Determination 2026/013

The compliance of part of a pool barrier with Building Code Clause F9

46 Bridgehampton Drive, Prebbleton, Christchurch

Figure 1: Digital rendering showing the proposed barrier design

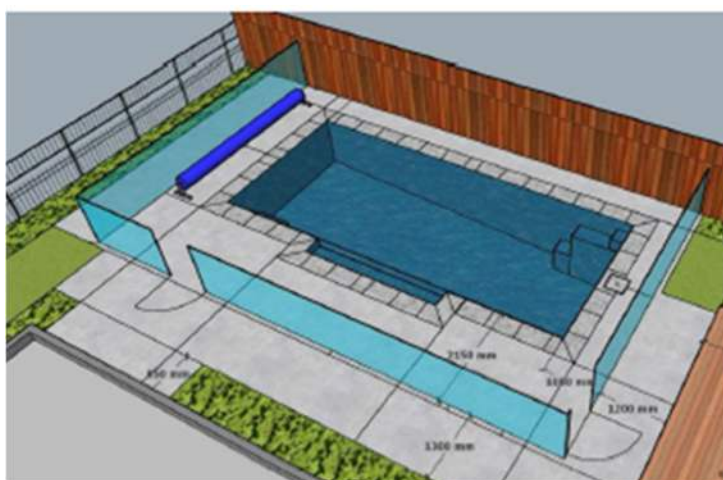
- 2.2. The pool barrier proposed in the building consent application consists of a 1200mm high glass barrier on three sides, and an 1800mm high timber boundary fence on the fourth side (see Figure 1). The glass barrier is 12mm wide. The boundary fence has palings on the inside (pool side) of the fence, and posts and horizontal rails on the outside. The horizontal rails are spaced 830mm apart².

- 2.3. On 23 December 2025, the authority sent an information request to the owners because it considered the pool barrier design did not comply with clause F9 due to the junctions between the boundary and internal fences. Correspondence between the parties followed, with the authority maintaining its view that the proposed pool

barrier where the internal fencing and boundary fence intersects did not comply with clause F9.3.3 in relation to access from the adjacent property and the top of the internal fence being a projection that would assist a child negotiating the barrier.

In this instance, the boundary fence forms part of the pool barrier. The owner cannot control what happens on the other side of the fence. To prevent a child climbing down from the top of the boundary fence into the pool area, a 900 mm climb-free zone is required. As the current distance between the boundary fence and the pool fence is only 600 mm, there is concern that a child could potentially use the pool fence to gain access to the pool area.

- 4.4. In this case, the junctions where the glass barrier abuts the timber boundary fence are 600mm below the top of the boundary fence. This creates horizontal projections which are greater than 10mm and within the 900mm “non-climbable zone”. As such, the proposed barrier does not comply with F9/AS1 paragraph 2.2.1(d), specifically the requirement for a non-climbable zone to be constructed as specified in paragraph 2.1.7.

- 4.9. The boundary fence is 1800mm high and the inside surface of the boundary fence is a vertical face with no hand or foot holds. Although the junctions with the 1200mm high internal barrier create a projection 600mm below the top of the boundary fence, the internal barrier is narrow at 12mm⁶ and made of glass, which I consider is not an inviting hand or foot hold for a child attempting to negotiate the inside of the barrier.

- 4.10. There are no other hand or footholds either on the face of the boundary fence or nearby where the internal fence meets the boundary fence to assist a child in climbing down. In my opinion, it would be very difficult for a child to use the top surface of the glass fence as the only hand or foot hold to climb down into the immediate pool area. Given the construction, in combination with the height of the boundary fence and the lack of hand or foot holds on its inside surface, I am of the

- 4.11. I am satisfied the proposed barrier will restrict access to the pool area by unsupervised young children and meets performance requirements F9.3.1 and F9.3.3 as an alternative solution.

- 5.1. In accordance with section 188 of the Building Act 2004, I determine the part of the proposed barrier, consisting of the 1800mm high timber boundary fence and its junctions with the 1200mm high internal glass fencing, complies with clause F9.
